File No.	2025-011-SP
Staff Report No.	PB-016-2025
Property Address	100 Grand Trunk Road, Stayner
Proposal Description	Phase 1: Building 1- Foodland (2375.62 m ²); Dollarama (998.91 m ²); Building 2 - LCBO (511 m ²); and Building 3 - McDonalds (376 m ²).

Report To: Chief Administrative Officer (CAO)
Report From: Rossalyn Workman, Community Planner
Report Date: April 14, 2025
Subject: Site Plan Approval – 100 Grand Trunk Road, Stayner
(Phase I)

THAT in consideration of a Staff Report respecting an amendment to the Site Plan Approval (File No. 2025-011-SP) at 100 Grand Trunk Road, Stayner where changes to the current approved Plans are proposed for the following commercial development: Building 1- Foodland (2375.62 m²); Dollarama (998.91 m²); Building 2 - LCBO (511 m²); and Building 3 - McDonalds (376 m²) the approval authority:

DRAWING SITE PLAN

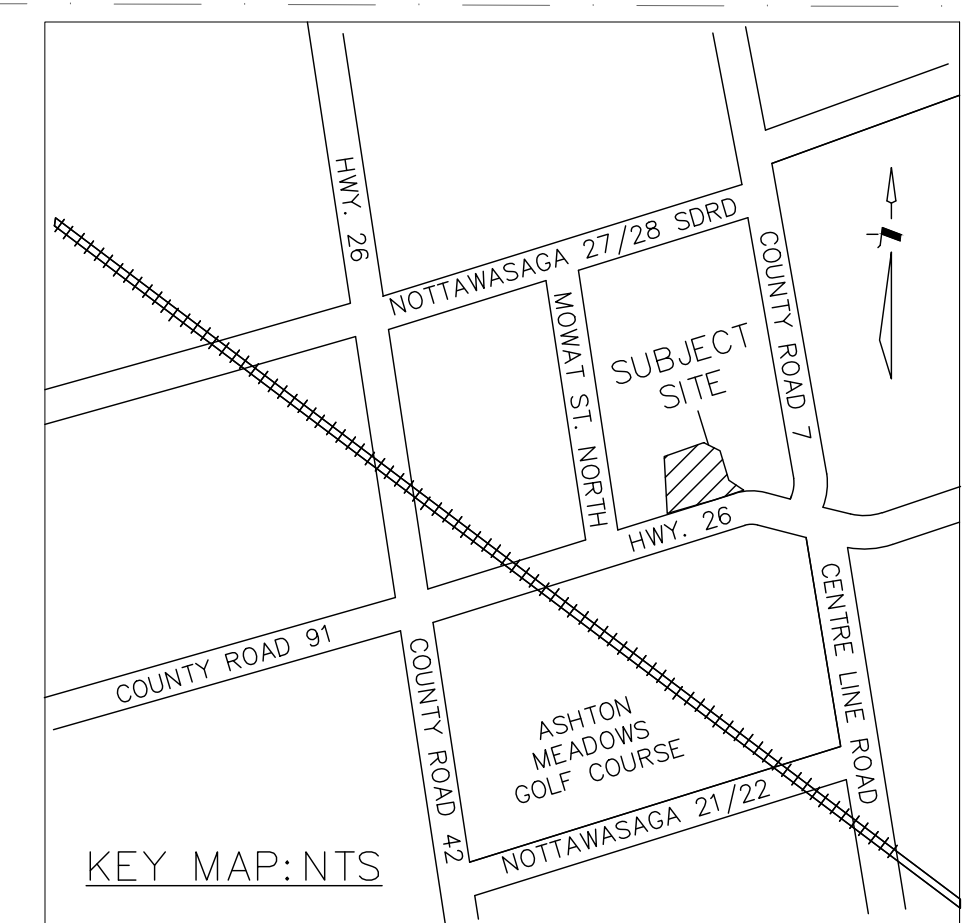
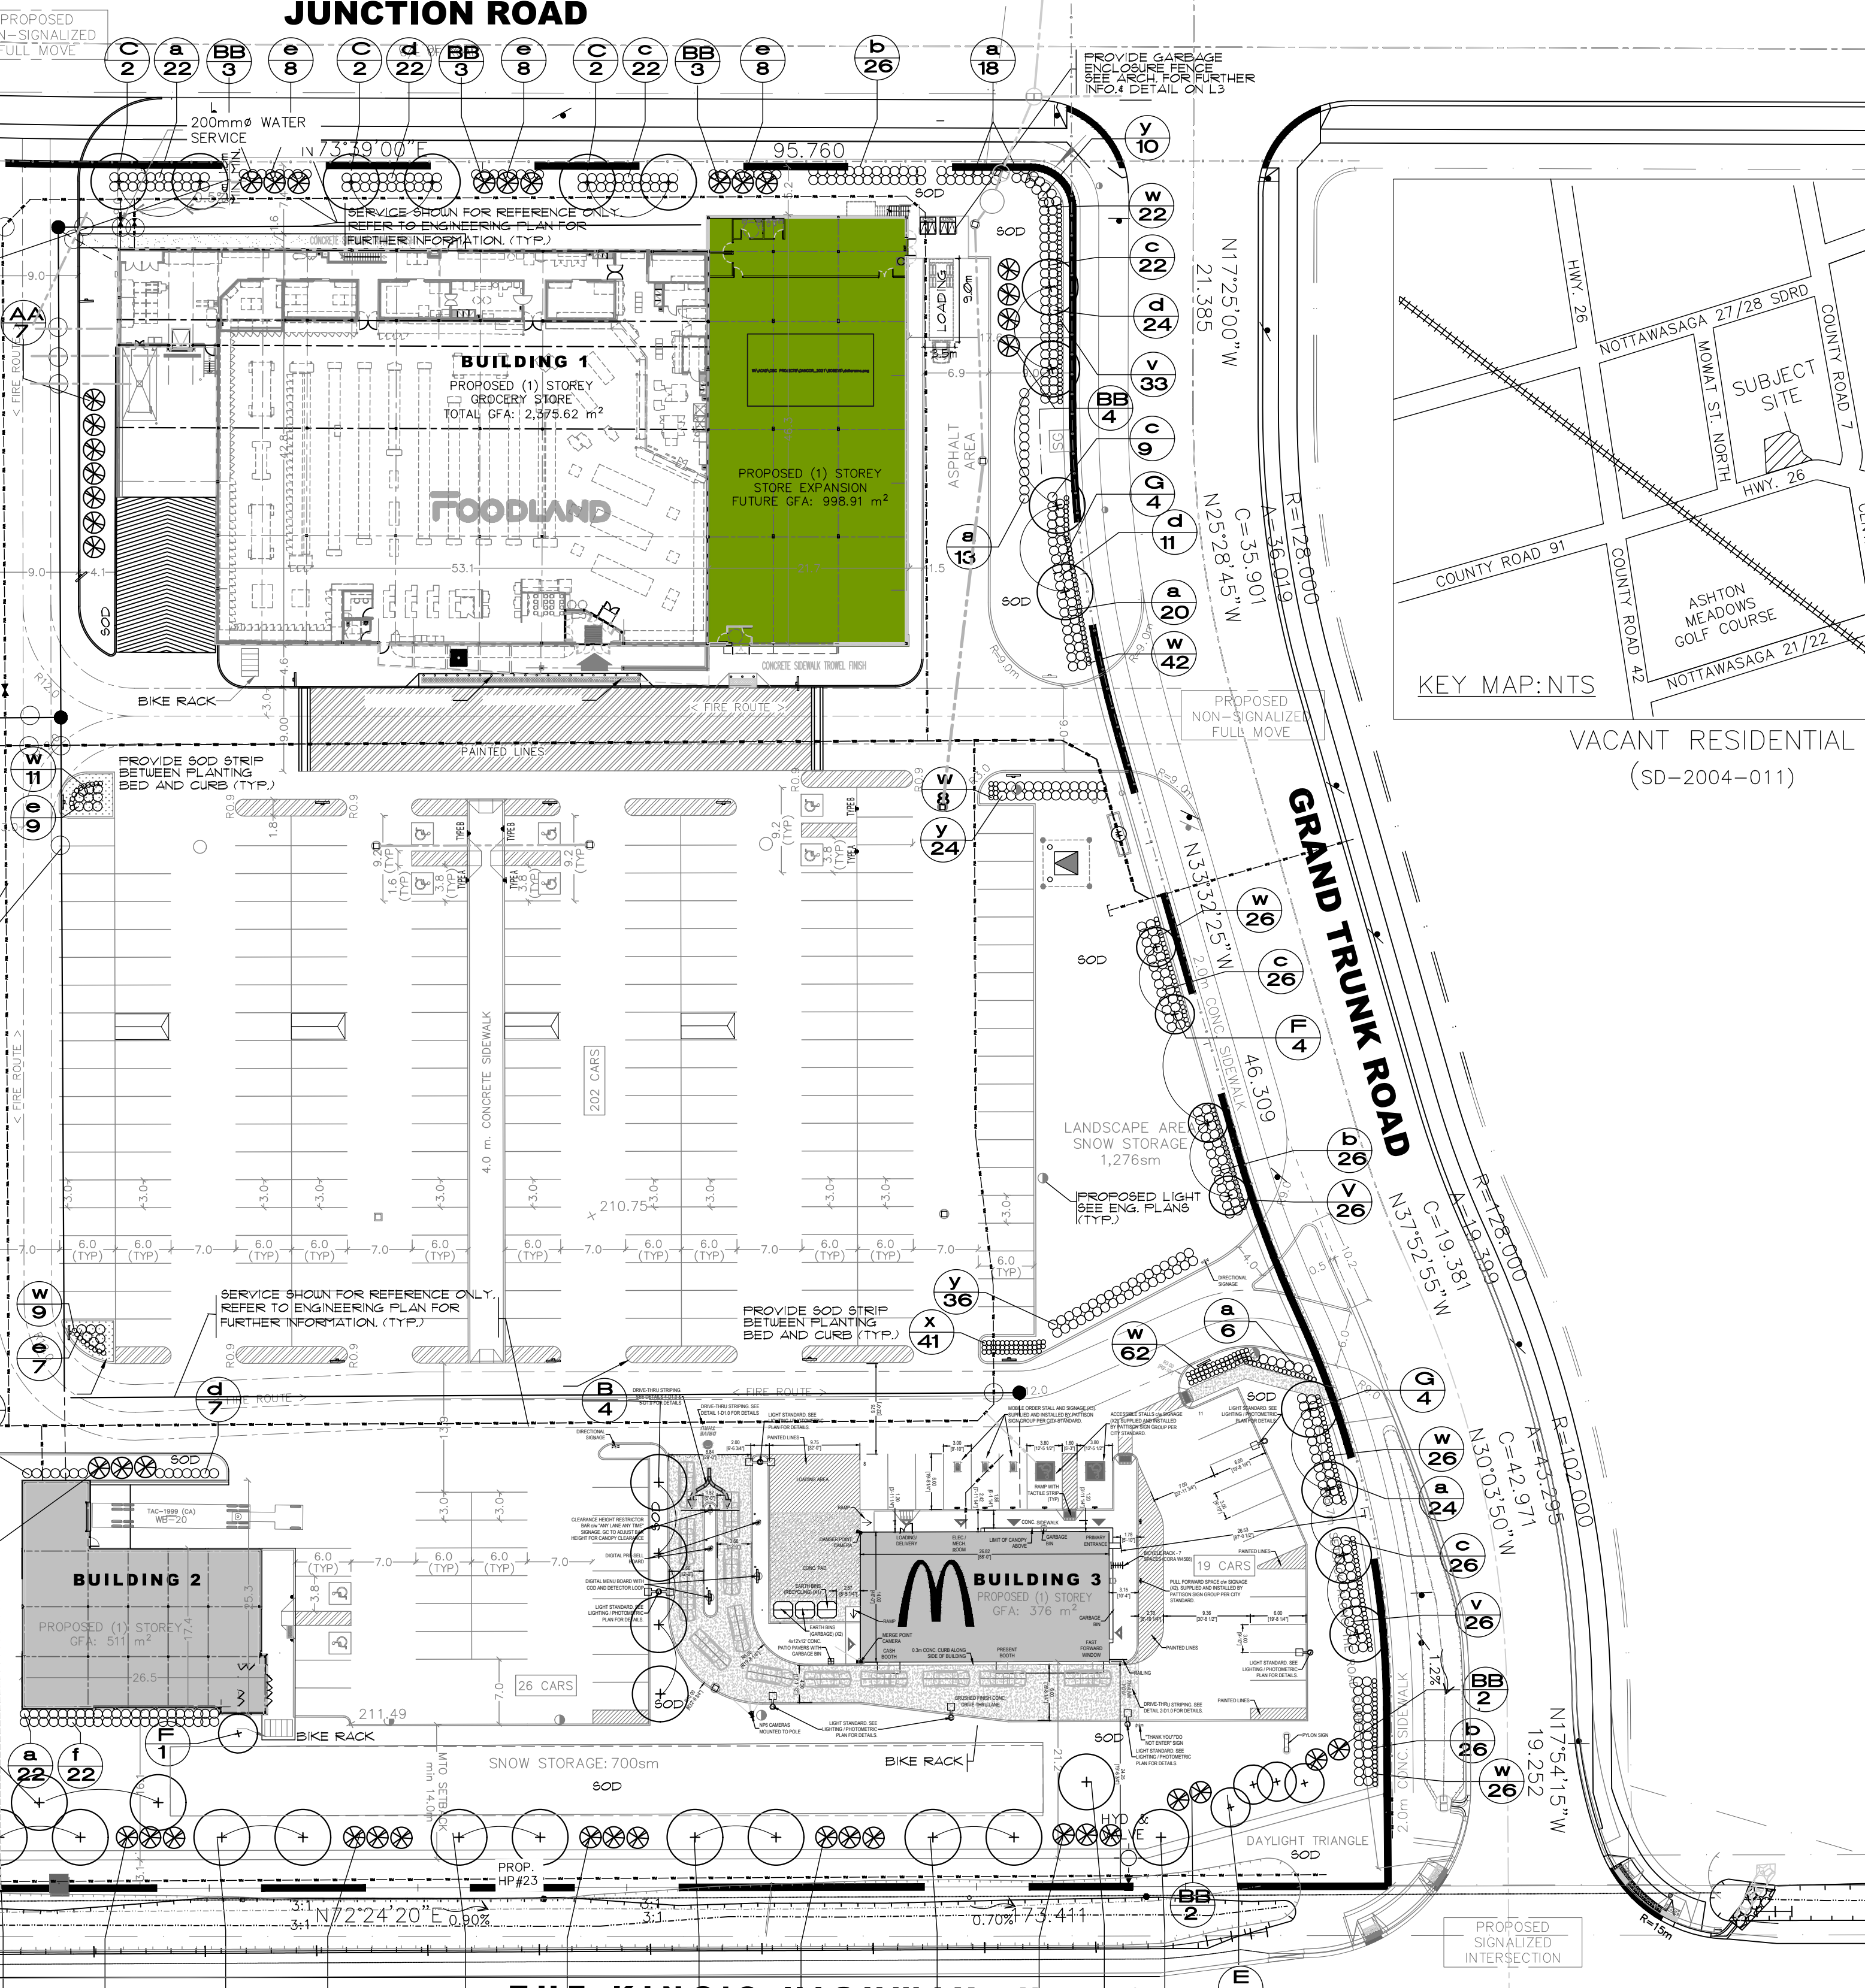
b.	That the applicant is successful in obtaining a Minor Variance to amend the following to the satisfaction of the Planning and Building Department: <ul style="list-style-type: none">- Section 2.7.1 Encroachments into Required Yards: to permit a landing and stairway that are larger than the maximum 1.2 m in width and depth, located in northern exterior side yard of Bulidng 1 -Dollarama, shown on A-1 Site Plan, dated March 3, 2025 .

c.	That the revised site plan, revised landscape plan, and revised engineering plans show, to the satisfaction of the Planning and Building Department: <ul style="list-style-type: none">- A note on the site plan stating the following: It is acknowledged that the maximum required number of parking spaces will not be less then 246 for the Phase 1 of the shopping centre, which are the current spaces available.- Please provide a detail and install four bollards that will be located to the north of the earth bins (waste disposal) on the McDonald’s site (Building 3).- Reinstate the following on the Landscaping Plan – 2 deciduous trees; 7 coniferous trees; 100 deciduous

DRAWING: LANDSCAPE PLAN

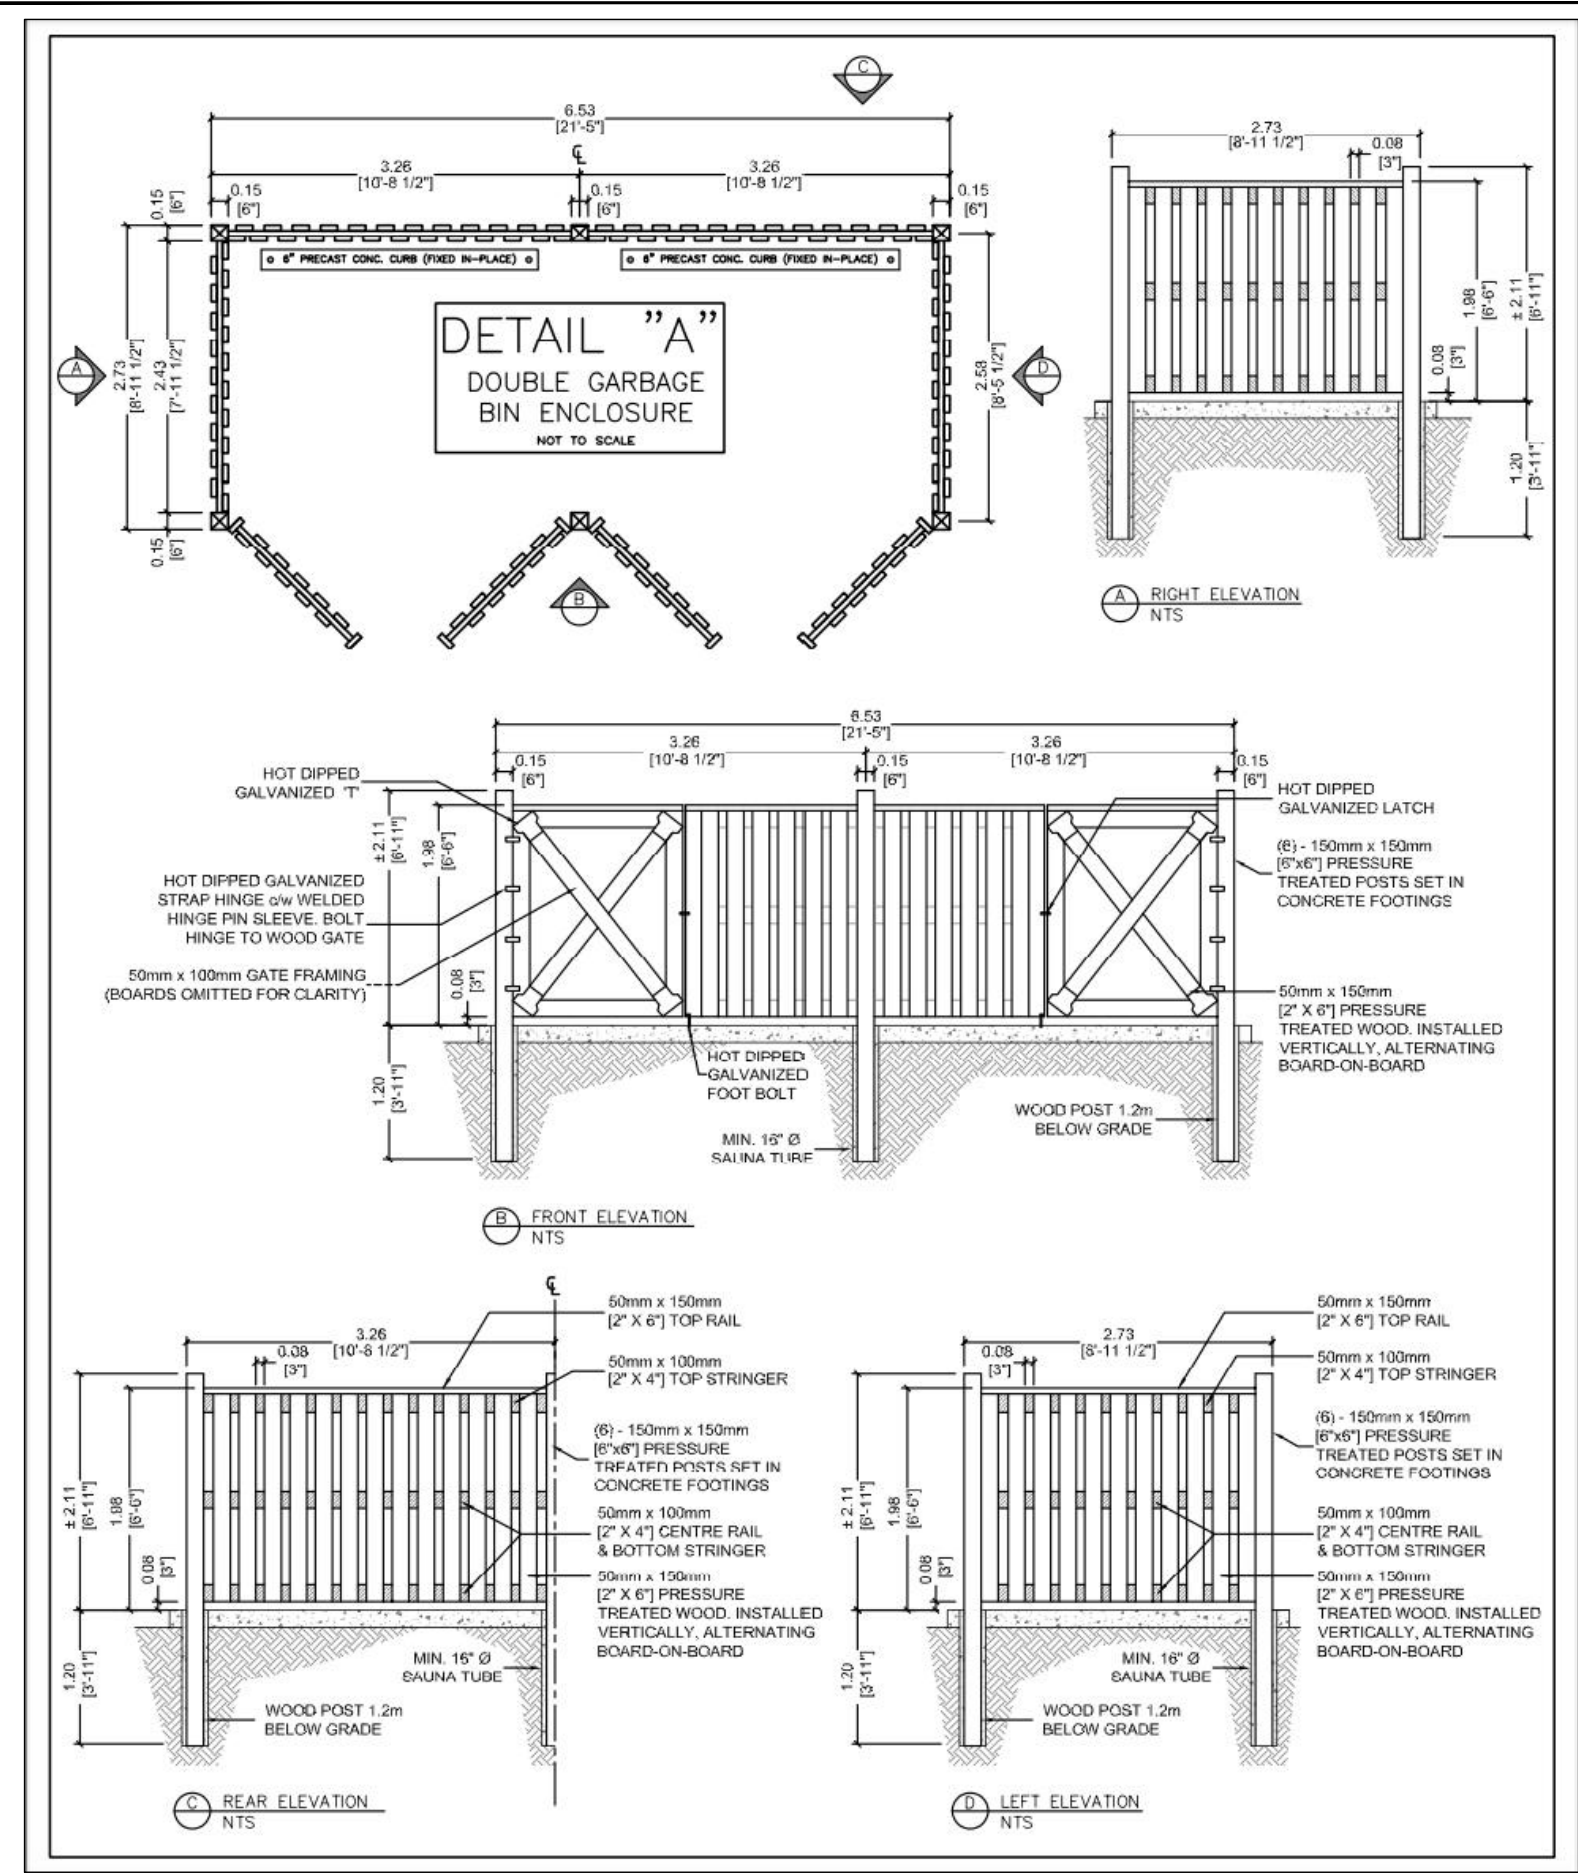
#	Condition	Date	Sign
	shrubs and 4 perennials, groundcovers and grasses. There were 113 trees removed from the previously approved landscaping plan. The total trees, shrubs and grasses should be 1086 and not 973.

1. Remove or relocate tree in the vicinity of the storm crossing between CBMH106B and CBMH106.

- d) Remove or relocate the tree in the vicinity of the storm crossing between CBMH106B and CBMH106.
 - e) Identify the correct orifice plate diameter.
